Nome Bunkhouse Interior Window Photos

Nome Bunkhouse 2019 Siding Installation Photos

Shows flashing details at existing windows

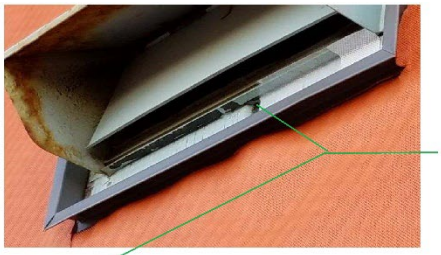
Can't have T-111 joints exposed to weather -- don't want wood surfaces for future paint paintenance...also need flat stock to cover wood so there is a flat surface to caulk against at J-chanel.

Slide flat stock flashing around penetrations per manufacturer's flashing details below:
